Oakland Harbor Turning Basins Widening

Comments and Responses to Comments

APPENDIX A-10: COMMENTS AND RESPONSES TO
COMMENTS
OAKLAND HARBOR TURNING BASIN
OAKLAND, CALIFORNIA

Figure 10. Total TEU Forecast to 2050 in All Scenarios¹⁰

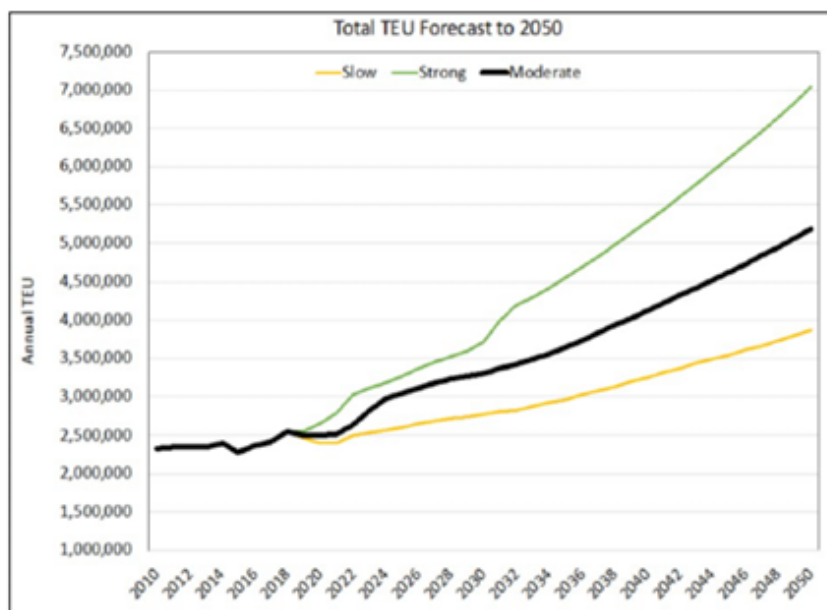
The statements made by the Army Corps in the EA are not entirely accurate. Although the use of larger ships to transport cargo to and from the Port may result in a reduction in ship emissions, which should have already been evaluated in the EA, the air quality and GHG analysis presented in the EA do not account for impacts from the increase TEU throughput that would result after two existing turning bases have been modified. Figure 10 of the EA shows that the Army Corps projected the number of TEU passing through the Port under a strong and weak economy. The figure indicates TEU throughput at the Port sharply increasing after 2029, which is the date the Project is expected to be completed. It is clear from this figure that the Port's future growth depends on the widening of the existing turning basins to allow ships with greater TEU capacity compared to the ships that presently call at the Port. To this end, modifying the existing turning basins would impact the freight activities at the Port. Although there will be fewer ships calling to the Port, due to the larger TEU capacity of the ships, the terminals at the Port would very likely have to acquire more onsite equipment to facilitate the transport of the TEUs off and on ships, and increase the number of heavy-duty diesel-powered trucks and locomotives to transport these TEUs out of the Port. Based on CARB's review of the air quality and GHG analysis and health risk assessment that the Army Corps prepared for the Project, there was no evaluation of the potential environmental impacts associated with the Project's impact on the Port's freight activities.

California Air Resources Board (CARB)		
Comment Number	Response	Location in IFR
CARB – 1	The IFR/EA explains in Section 5.7 that the Project will not induce growth, or otherwise increase cargo throughput. It is for that reason that no modeling of freight activities is justified because the Project will have no freight impacts. The project’s reductions in vessel transit and emissions are an expected benefit but are unrelated to the fact that the Project won’t impact freight activities. Further, the Project’s proposed construction timeline is not directly related to the independent growth projection referenced in the comment letter. The graph shows the baseline estimation of total TEU forecast to 2050, growth expected to occur with or without the project. If those growth projections end up being accurate, vessel calls are expected to increase as well, but with Project conditions, larger, newer ships would carry more cargo allowing for more efficient navigation. The study does not support a causation connection between the growth in this graph and the Project and it is wrong for CARB to assume there is one. The air quality and greenhouse gas analyses account only for the construction emissions for the Project and documents the reduction of idling hours, thus the reduction of emissions from vessels. See Section 6.13 and 6.14 and GC-1. Additionally, CARB incorrectly assume that ship size determines cargo quantity. Instead, the amount of cargo is determined by the market and demand. Large vessels already call the Port and terminal operators manage the loading and unloading of both large and small vessels today. Terminal operators routinely adjust operations to manage and control changes in container volumes related to holiday surges and shortened work weeks due to no-work holidays. The existing conditions which include terminal operators adjusting to servicing varying container volumes temporally is anticipated to continue to meet the projected future container vessel fleet mix. The Project was properly scoped and analyzed in accordance with all project components. Whether there is significant cargo increases or not, the same amount of cargo can be brought on fewer, larger ships, or more, smaller ships. Either way, the same amount of cargo is brought to the Port. The turning basin expansions would allow for more efficient ship transit, allowing a greater number of larger ships to call at the Port more easily. The larger ships would carry more cargo and may spend more time at harbor than a smaller ship. Additional cargo is not anticipated from the widening of the turning basin, as the same throughput of containers is anticipated, and therefore no change to the Port's operations is included in any project alternative. As the greenhouse gas emissions analysis shows, it is anticipated that the Project will result in less greenhouse gas	5.7: Evaluation of Potential for Induced Growth, 6.13: Air Quality, 6.14: Greenhouse Gases

Figure 4: Carbon intensity of container ships by size bin.¹⁴

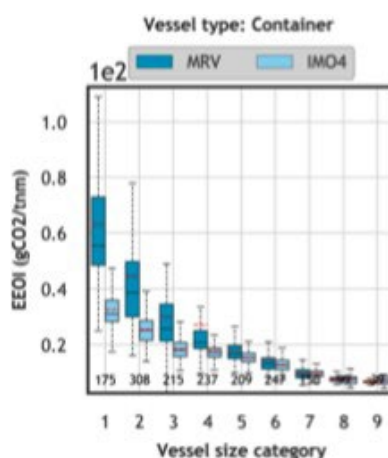
Larger vessels are more fuel efficient per nautical mile sailed (Figure 4), and correspondingly the carbon intensity of larger container vessels per ton-nautical mile is lower.¹⁵ Per the Fourth IMO Greenhouse Gas Study (GHG4), Table 60, the carbon intensity of IMO Category 9 vessels (20,000+ TEUs), is 7.7 gCO₂/t-nm, compared to 8.0 gCO₂/t-nm for Category 8 container vessels (14,500 - 19,999 TEUs). Data from the Port of Oakland's 2020 Emission Inventory, recreated in Table 8 below, show that 50.6% of calls at the Port are from

Figure 6: Mean turn times from 2021 - 2023 for trucks calling at Port of Oakland container terminals.

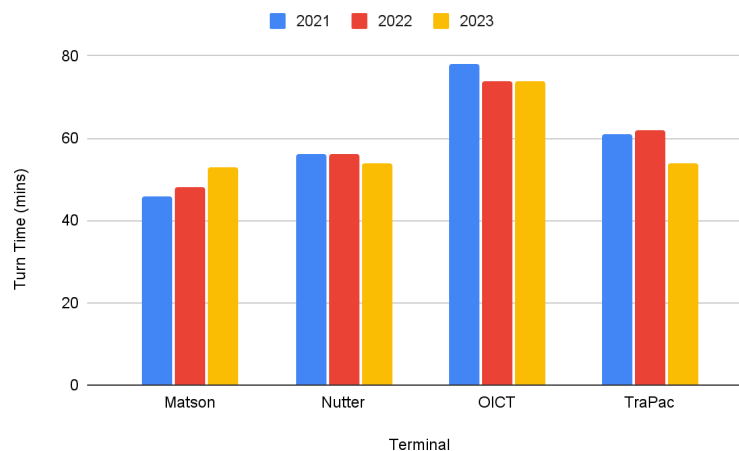
in 2005 and 2012, and may not be fully reflective of the current situation. Total turn times, that is the time from when a truck enters the terminal gate, loads and/or unloads cargo, and leaves the terminal, are shown in Figure 6.²³ These data
